New and extended approval according to ATEX and IECEx.

PSE EX					0118.2193	
creation date	created by	release date	released by	notification no.	revision	page
2013-11-18	halterma	2014-03-10	halterma	25236	-	1 of 2

(example of PSE M16 EX)

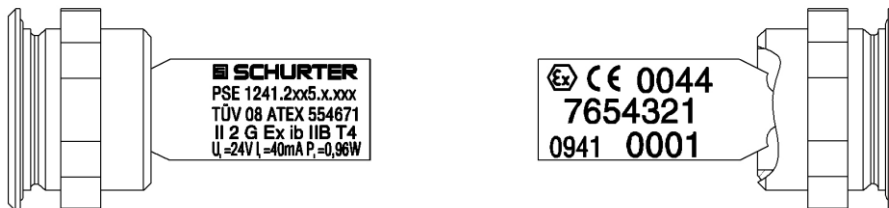
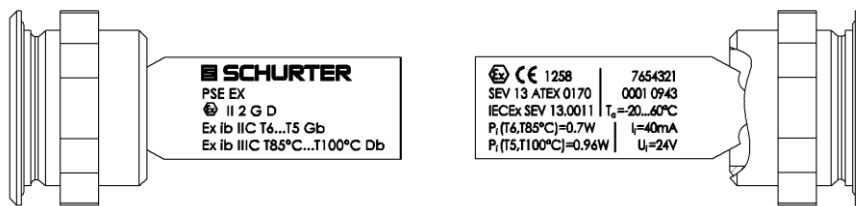
3 Detailed description of change

Approval up to now:

Ⓔ II 2 G Ex ib IIB T4

TÜV 08 ATEX 554671 X (EC-Type Examination Certificate)

New approval:

⊕ II 2 G Ex ib IIC T6...T5 Gb

⊕ II 2 D Ex ib IIIC T85°C...100°C Db

SEV 13 ATEX 0170 (EC-Type Examination Certificate)

IECEX SEV 13.0011 (IECEX Certificate of Conformity)

Form: New approval
Fit: N/A
Function: N/A
Production Site: New approval
Product Label: Modified tag
